# Texas Commission on Environmental Quality

## Attachment 2 – NOD Responses

Municipal Solid Waste Permit Amendment No. 1848A  
 Beck Landfill  
 6<sup>th</sup> Notice of Technical Deficiency

BECK LANDFILL  
GUADALUPE COUNTY, TEXAS  
TCEQ PERMIT APPLICATION NO. MSW 1848A

NOD Response 4 – Part II Attachment G and Part III Attachment E, Figure E-9 (updated)

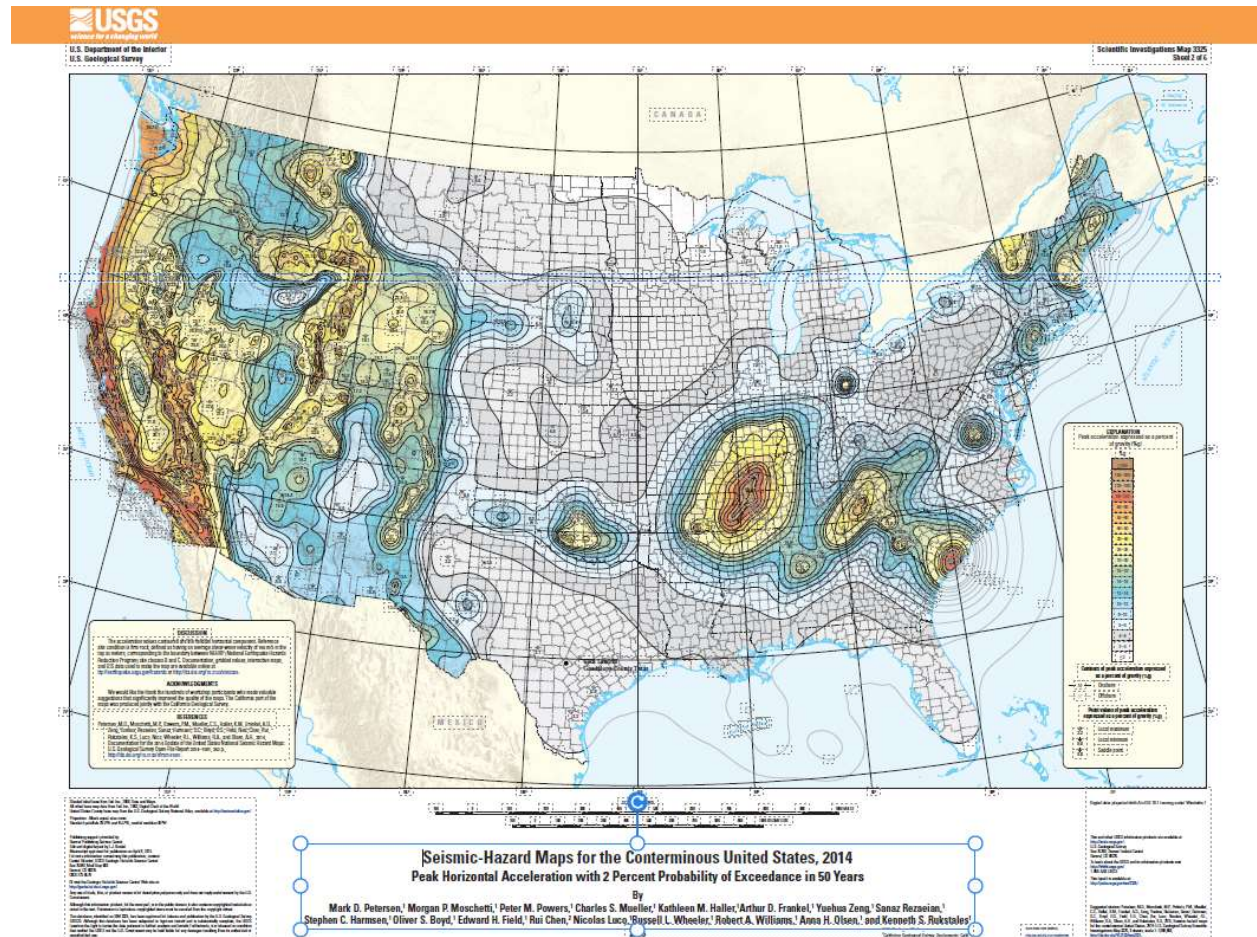
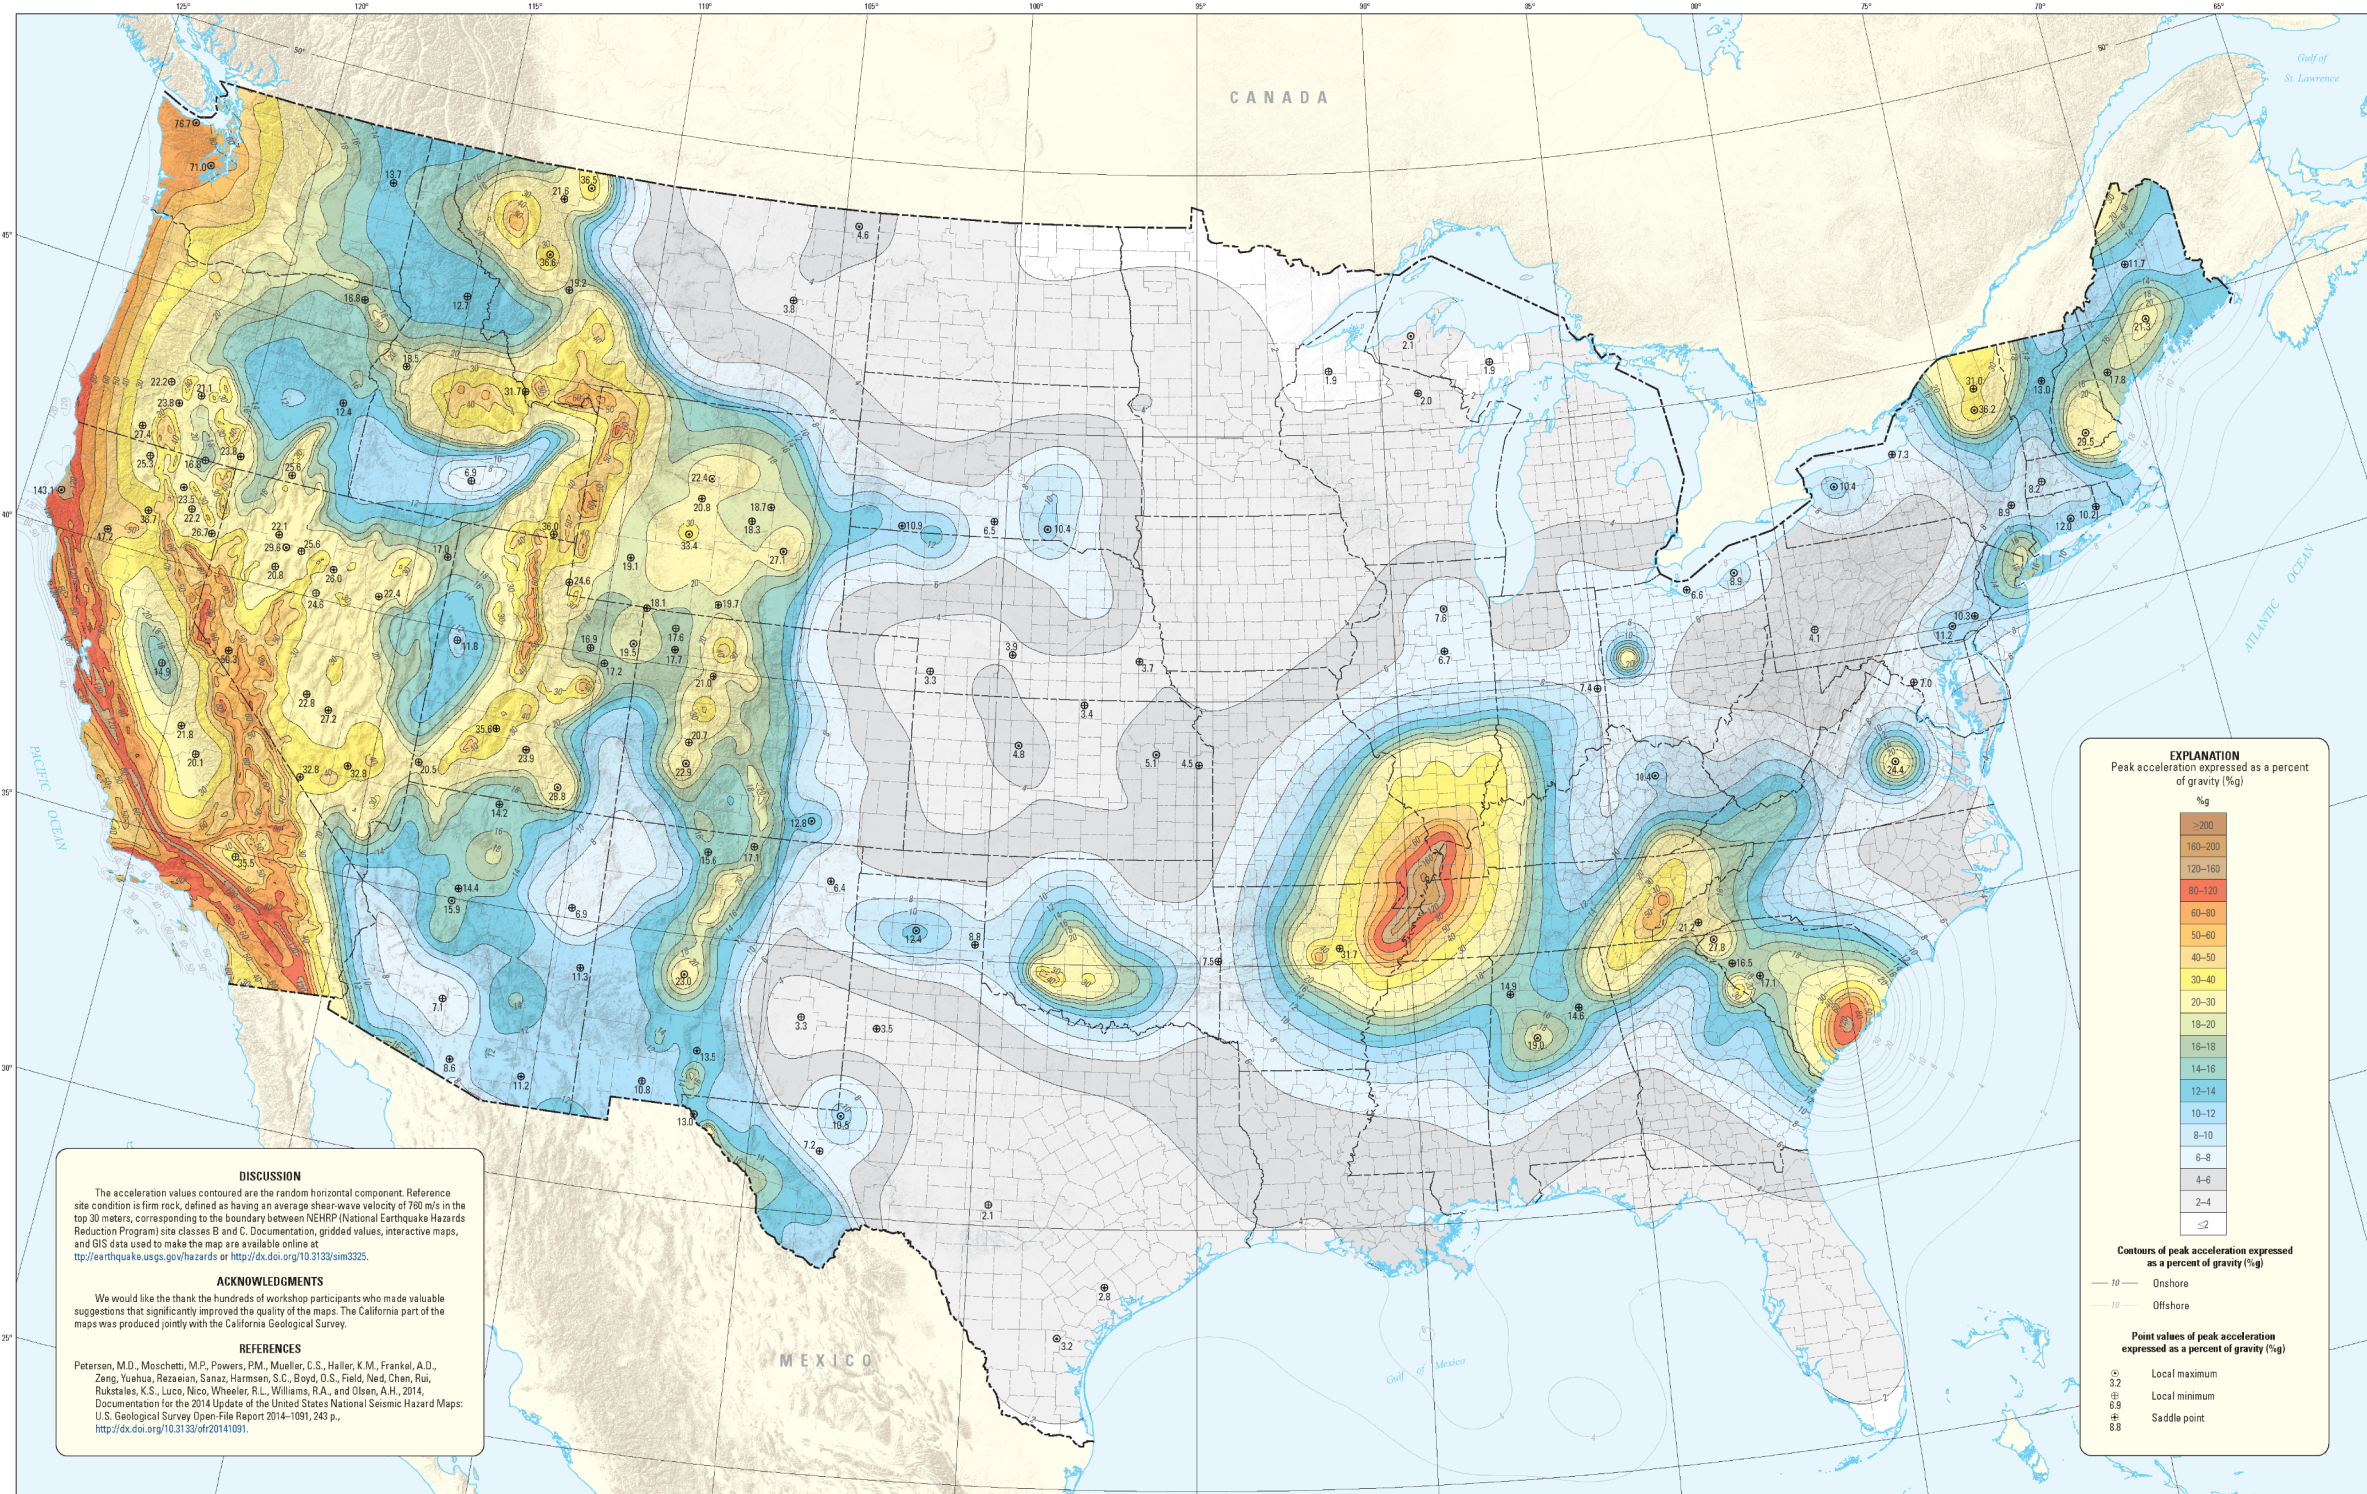
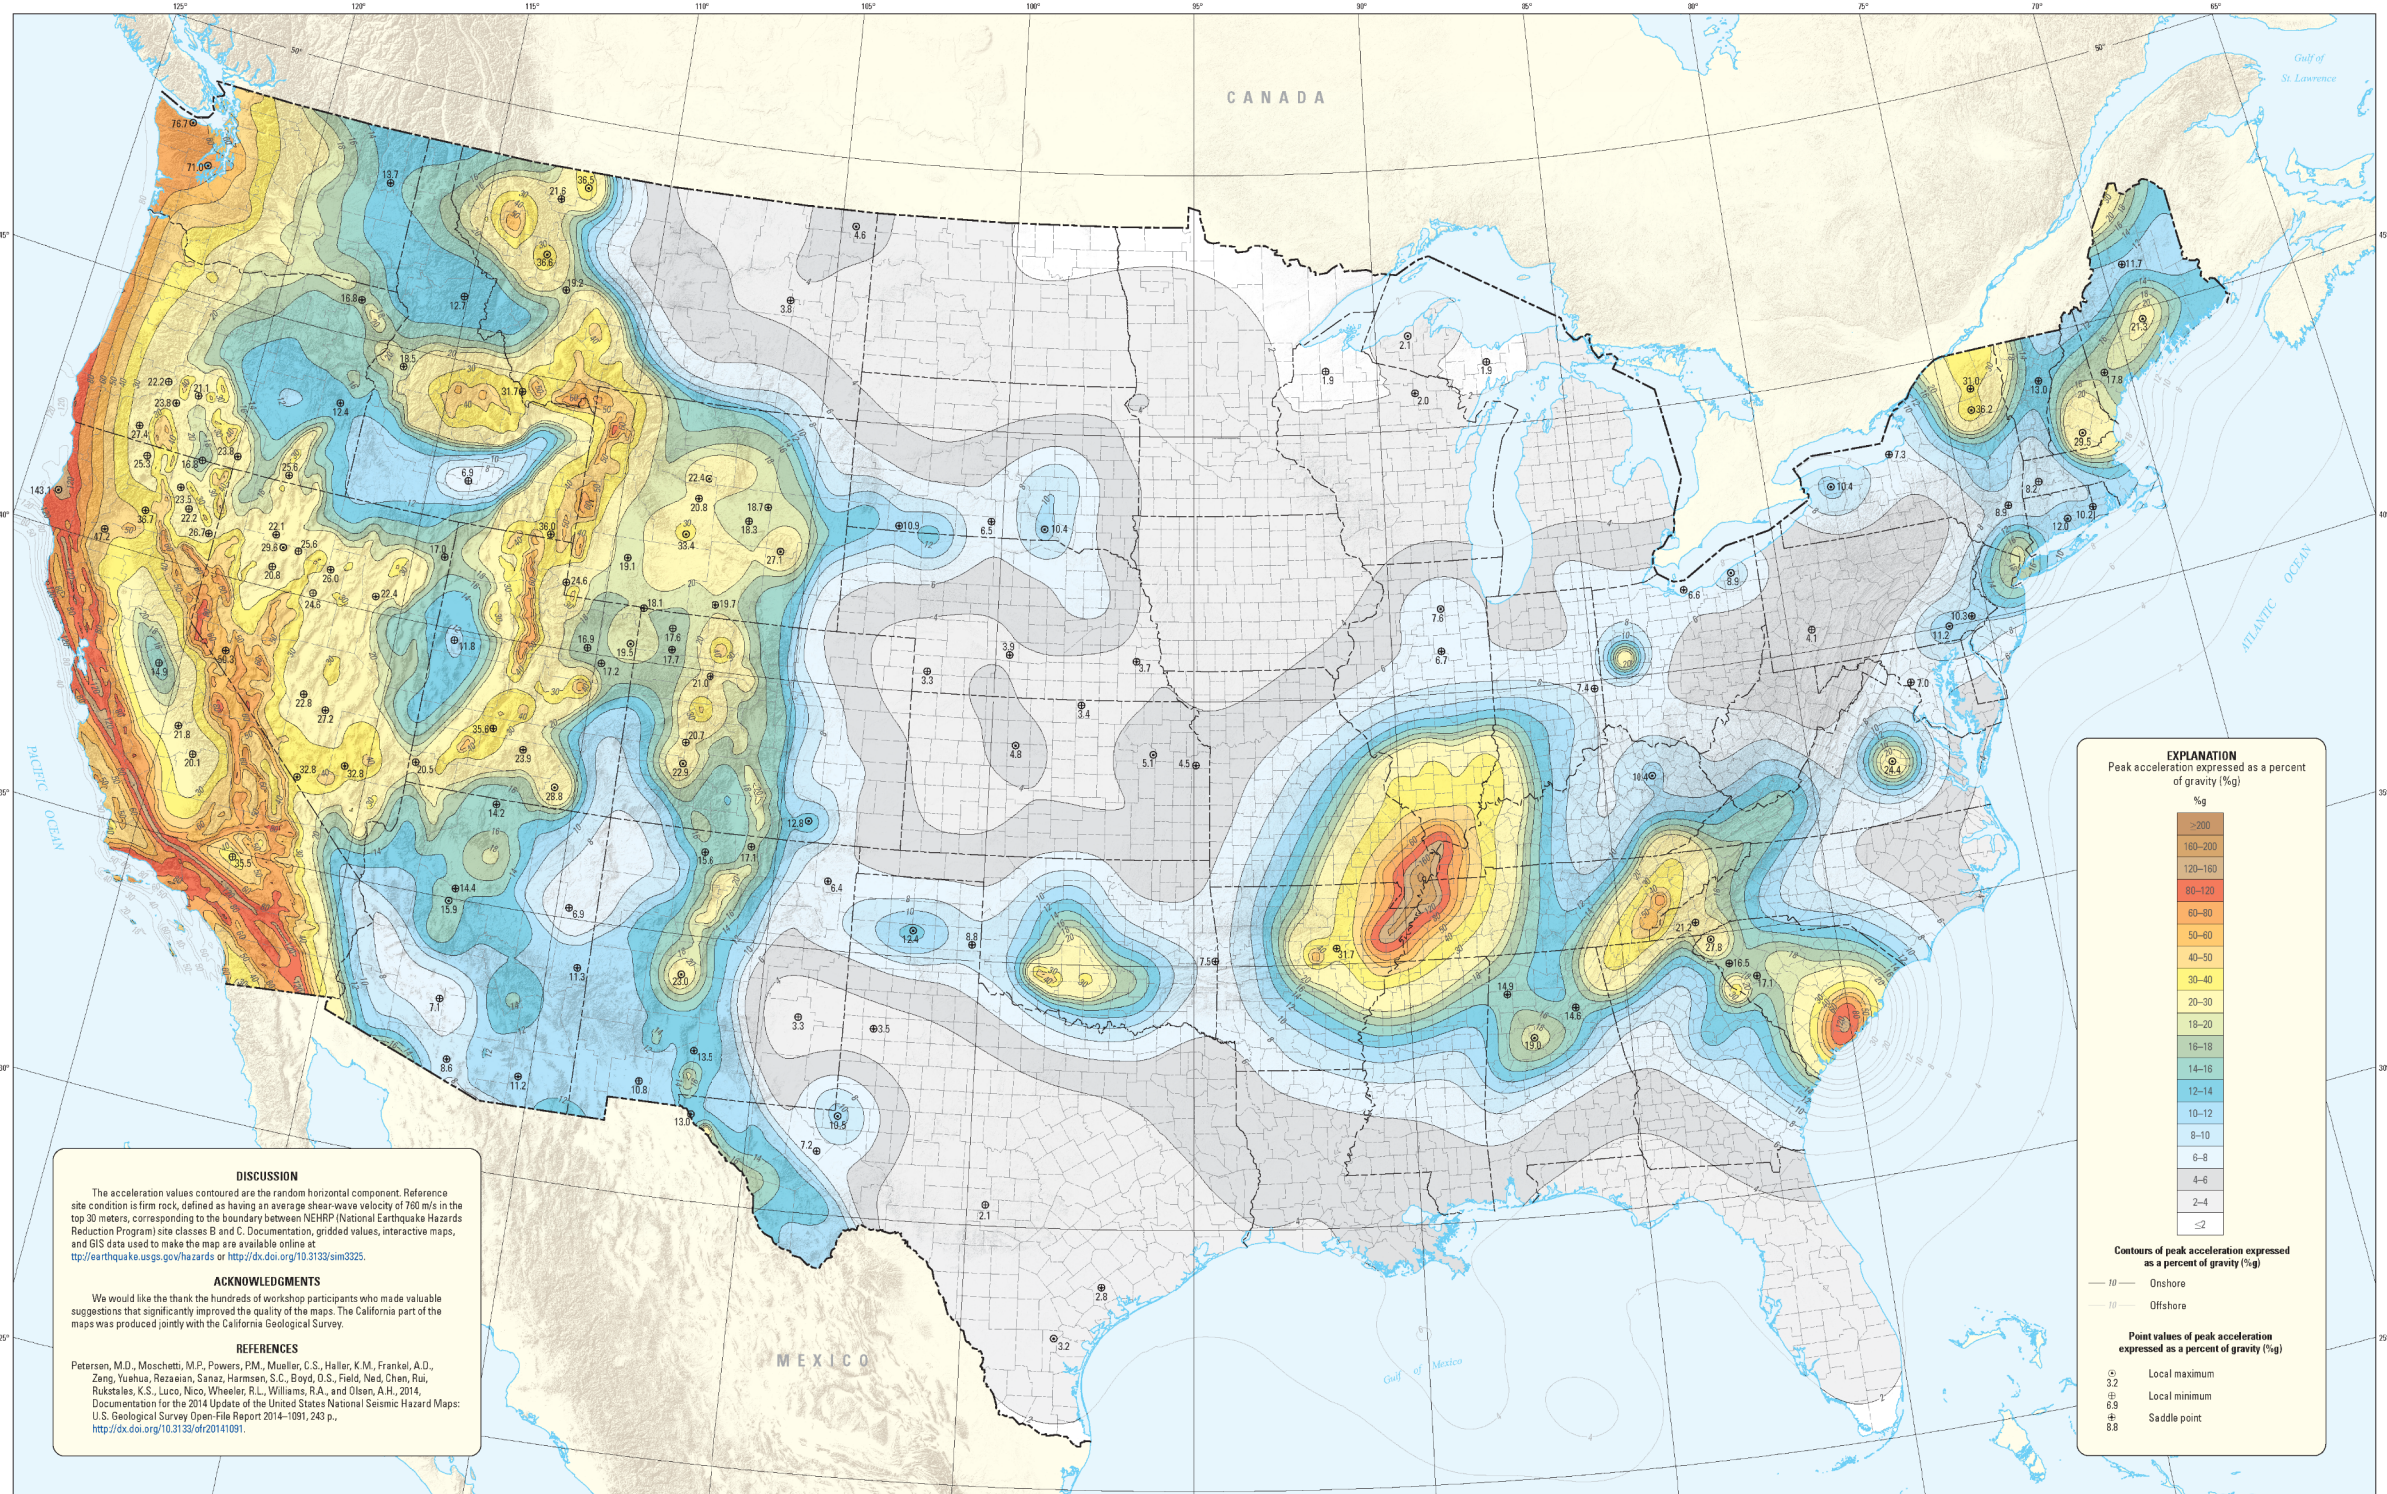
| NOD ID | MRI ID | Citation                                | Location  | NOD Description  | Response   |
|--------|--------|---|---|--|--|
| 4      | 150    | 330.61(j)(3), 330.63(e)(2), and 330.557 | Part II, Attachment G, and Part III, Attachment E, Figure E-9 | Provide a legible copy of a USGS seismic hazard map that shows information in the format required by 330.557.<br>Use the map at the location described in item 9 in NOD4 table—2014 map showing peak horizontal acceleration with 2% probability of exceedance in 50 years, available at <a href="https://pubs.usgs.gov/sim/3325/">https://pubs.usgs.gov/sim/3325/</a> (on that webpage, scroll down to Contents, click on Sheets, pick SIM3325_sheet2.pdf).<br>Provide a copy of the map in Part II, Attachment G-5, and a copy of the same map in place of current Figure E-9 in Part III, Attachment E. | The USGS Seismic Map is included in Part II, Attachment G, page 5a in 11x17, full color, with the whole US shown.<br><br>The same map is provided as Figure E-9. |

peak horizontal acceleration zone of 2-4% within the Horizontal Acceleration with 2% probability exceedance in 50 years. Therefore, the Beck Landfill does not appear to be at seismic risk (see below and Figure G5-a on the following page).
